HORNSEA PROJECT THREE OFFSHORE WIND FARM

**NATURAL ENGLAND**  
**WRITTEN SUBMISSION FOR DEADLINE 3 – Issue Specific Hearing 2**  
**Part 2: Benthic**

**Annex 2.2B Natural England and JNCC responses to Applicant's responses to Natural England WR in relation to Benthic Ecology**

Dated 14<sup>th</sup> December 2018

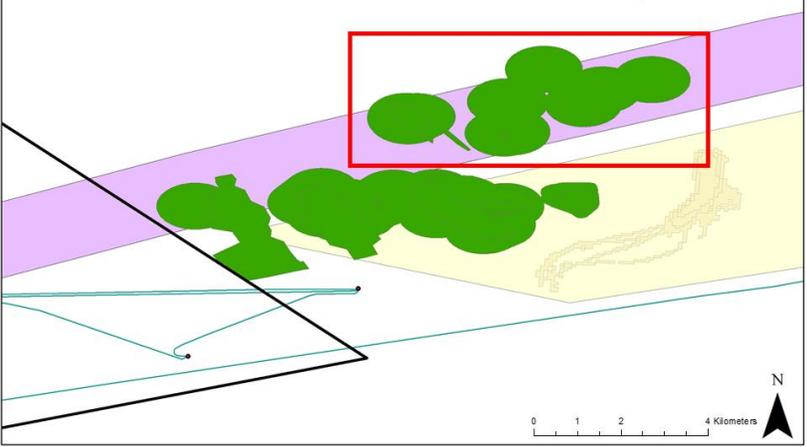
| 3 | <p>The Applicant refers the Ex.A to Figure 2.9 of Volume 2, Chapter 2: Benthic Ecology of the Environmental Statement (APP-062) which shows the potential future Annex I Sabellaria spinulosa reef within the Hornsea Three offshore cable corridor (i.e. the area highlighted in the Natural England Written Representation).</p>                |  |

| <p>during one previous survey, so is similarly not considered to represent an area of ‘established reef’. The latest data points mapped along the southern boundary of the offshore cable corridor, coinciding with potential future Annex I S. spinulosa reef Area D in Figure 2.9 of Volume 2, Chapter 2: Benthic Ecology of the Environmental Statement, is where reefs were also mapped during the original Saturn Reef survey in 2003 and the JNCC survey in 2013. This was identified as an area of higher confidence reef in Volume 2, Chapter 2: Benthic Ecology of the Environmental Statement. The Applicant acknowledges that this is an area with the greatest potential for S. spinulosa reef to be present prior to construction but would also note that Area D lies within the offshore cable corridor working area and is therefore out with the area of potential direct impact from cable installation. While the JNCC data also show additional records in the vicinity of Areas A and B, which do coincide with the Hornsea Three offshore cable corridor, the assessment presented in Table 2.21 of Volume 2, Chapter 2: Benthic Ecology demonstrates that there is sufficient space in the remaining offshore cable corridor to allow for micrositing around these features.</p> | <p>The latest version of the UK reef layer (v8) is an updated representation of our scientific evidence and opinion on extent and distribution that ensures parity between fisheries management layers and habitat mapping layers.</p> <p>We <b>agree</b> with the applicant that survey data show the ephemerality of <i>Sabellaria</i> presence within the Saturn Reef region. Because of this, we continue to consider that precaution is essential when managing this Annex I feature offshore, and disagree with the Applicant’s use of their Figure 2.9 of Volume 2, Chapter 2: Benthic Ecology of the Environmental Statement as a baseline for <i>Sabellaria</i> presence.</p> <p>We <b>disagree</b> that the Applicant’s assessment presented in Table 2.21 of Volume 2, Chapter 2: Benthic Ecology of the Environmental Statement demonstrates that there is sufficient space in the remaining offshore cable corridor to allow for micrositing around these features, and we consider that there is a significant risk of further impairment of the conservation objectives if the operations occur.</p> <p><b>Reef layers</b></p> <p><i>Availability of evidence</i></p> <p>As requested at the offshore ecology hearing, we will provide publicly available material depicting <i>Sabellaria</i> data and metadata within NNSSR for <b>Deadline 4</b>. This has previously been provided several times in graphic format to the Applicant throughout the consenting process.</p> <p><i>Extent polylines</i></p> <p>We would also like to provide further information as to the process undertaken to consider reef extent in the areas questioned by the Applicant, which we believe to be those enclosed in the red box below:</p> |

|   |  |  <p><b>Legend</b></p> <ul style="list-style-type: none"> <li><span style="color: green;">■</span> Area to be managed as Annex I Reef DRAFT output as of 1/11/2018. Finalised layer to be available before January 2019</li> <li><span style="border: 1px solid black; display: inline-block; width: 10px; height: 10px;"></span> North Norfolk Sandbanks and Saturn Reef cSAC/SCI</li> <li><span style="background-color: #d9ead3; border: 1px solid black; display: inline-block; width: 10px; height: 10px;"></span> Aggregate production areas</li> <li><span style="background-color: #f4cccc; border: 1px solid black; display: inline-block; width: 10px; height: 10px;"></span> UK Dredging_2017</li> <li><span style="background-color: #e6e6fa; border: 1px solid black; display: inline-block; width: 10px; height: 10px;"></span> Cable_Corridor_ETRS89_v6_20180207</li> <li><span style="border-bottom: 1px solid blue; display: inline-block; width: 10px;"></span> pipeline_eab_201807</li> </ul> <p style="text-align: right; font-size: small;">JNCC @ 2018 except<br/>Cable_Corridor_ETRS89_v6_20180207 @ Orsted, aggregate production areas and UK_Dredging_2017 @ The Crown Estate 2018, pipeline_eab_201807 @ UKOilandGasData 2018</p> <p>The area in question is comprised of 500m margins around point/polyline records of reef. These records are those stemming from the 2013 Cefas/JNCC North Norfolk Sandbanks cruise. The 500m margin was made around points only where the segment was classed as “Low”, “Medium” or “High” reefiness index, as all three are intrinsically reef.</p> |
